LIGO Laboratory

Date:	28 March 2008
Refer to:	L080019-01
Subject:	Response to Comments and Questions on the COC Preliminary Design Document (PDD)
Authors:	Helena Armandula, GariLynn Billingsley, Bill Kells, Gregg Harry (COC PDR team) and the COC PDR review committee: Doug Cook, Dennis Coyne (chair), Peter Fritschel, Eric Gustafson, David Reitze, Norna Robertson, Ken Strain, Bill Tyler, Hiro Yamamoto

COC Preliminary Design Document (PDD)

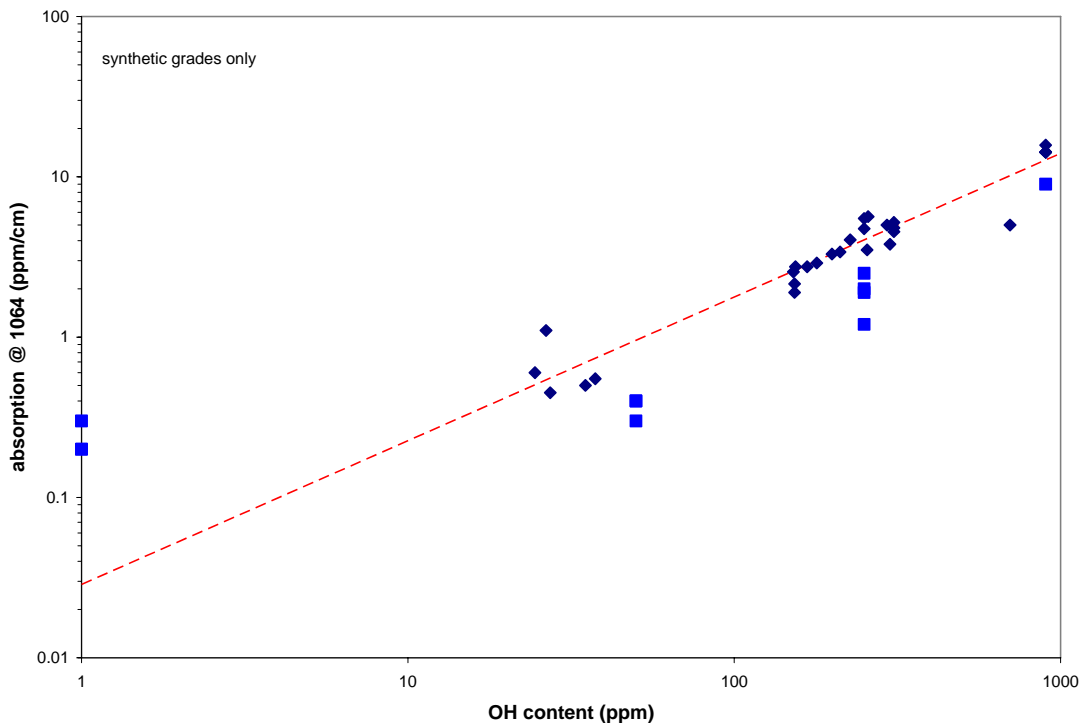
40) Cite a reference for the absorption vs OH content data that supports the claim that 3001 material will have an absorption of < 0.02 ppm/cm. (Also either state the units of the slope and explain how it is relevant, or omit.) The only data that I'm aware (a collection provided by Heraeus; see figure below) requires an extrapolation of over an order of magnitude in OH level. Is there any data on absorption for Heraeus 3001?

No one can measure the expected absorption at the 0.02 ppm/cm. More importantly we only need absorption of $< \sim 0.2$ ppm/cm. These two points should be mentioned in the PDD text.
